**TOWN OF TRUMBULL, WATER POLLUTION CONTROL AUTHORITY**  
**RFP # 6297**  
**TRUMBULL BEARDSLEY PUMP STATION COMPREHENSIVE UPGRADE**  
**ADDENDUM NO. 4**

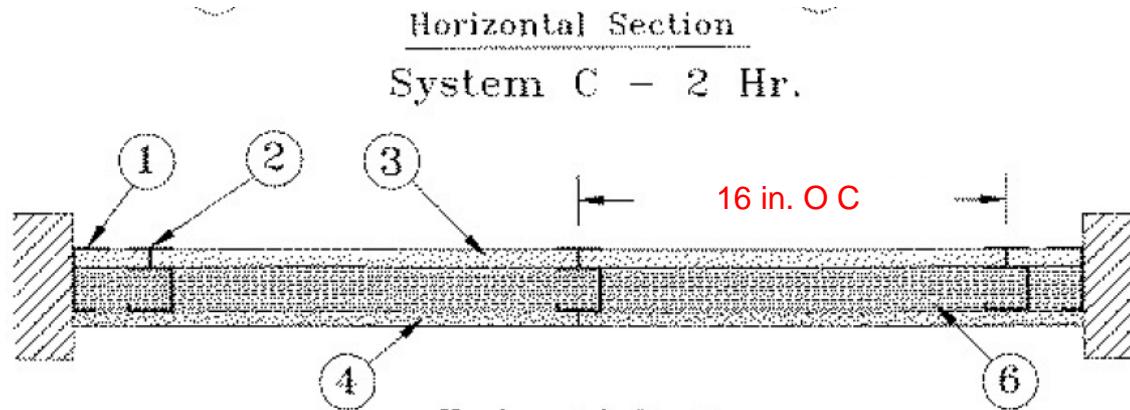
1. Insert New “2 Hour Shaft Wall Assembly Detail” as included in the Attachment to the Addendum on Drawing Sheet A-6.
2. Revise Mounting and Model of AC-1 and AC-2 in Ductless Split System Schedule on Sheet H-6 to read “Mounting: Ceiling” and “Model: PLA”.

2. Question: Drawing A-3 – Please provide a detail for the shaft wall assembly required for Stair No.2 and Odor Control Room

6. Question: On drawing A-3 first floor plan, what is the meaning of the note: “2 hour shaftwall assembly on walls as shown and on ceiling in stair 2 and odor control room?

Response: Detail provided as an Attachment to this Addendum.

Response: Refer to Detail provided as an Attachment to this Addendum for the 2 Hour Shaft Wall Assembly construction. This is to be installed for fire rating of the noted spaces.

A. DETAIL BASED ON UL DESIGN NO. U415, BXUV - FIRE RESISTANCE RATINGS - ANSI/UL 263 FOR NONBEARING 2 HR WALL.

1. Floor, Side and Ceiling Runners — "J" - shaped runner, min 4 in. deep, with unequal legs of 1 in. and 2 in., fabricated from min 20 MSG galv steel. Runners positioned with short leg toward finished side of wall. Runners attached to structural supports with steel fasteners located not greater than 2 in. from ends and not greater than 24 in. OC.

2. Steel Studs — "C-H" - shaped studs, min 4 in. deep, fabricated from min 20 MSG galv steel. Cut to lengths 3/8 to 1/2 in. less than floor-to-ceiling height and spaced 16 in. OC.

3. Gypsum Board — Gypsum liner panels, nom 1 in. thick, 24 in. wide. Panels cut 1 in. less in length than floor to ceiling height. Vertical edges inserted in "H" portion of "C-H" studs or the gap between the two 3/4 in. legs of the "E" studs. Free edge of end panels attached to long leg of vertical "J" - runners with 1-5/8 in. long Type S steel screws spaced not greater than 12 in. OC. When wall height exceeds liner panel length, liner panel may be butted to extend to the full height of the wall. Horizontal joints need not be backed by steel framing.

4. Gypsum panels, with beveled, square or tapered edges, nom 3/4 in. thick, 48 in. wide, applied vertically or horizontally, secured with 1-1/4 in. long Type S steel screws spaced 8 in. OC along vertical edges and 12 in. OC in the field when installed vertically or 8 in. OC along the vertical edges and in the field when installed horizontally. Horizontal joints need not be backed by steel framing. Screws along side joints offset 4 in. Requires min 4 in. deep framing per Items 1, 2 and 3. Requires min 3 in. thick mineral wool batts per Item 6.

5. Joint Tape and Compound. Joints on outer layers of gypsum boards covered with paper tape and joint compound. Exposed screw heads covered with joint compound.

6. Batts and Blankets. Min 3 in. thick mineral wool batts, friction fitted between the studs and floor and ceiling runners.
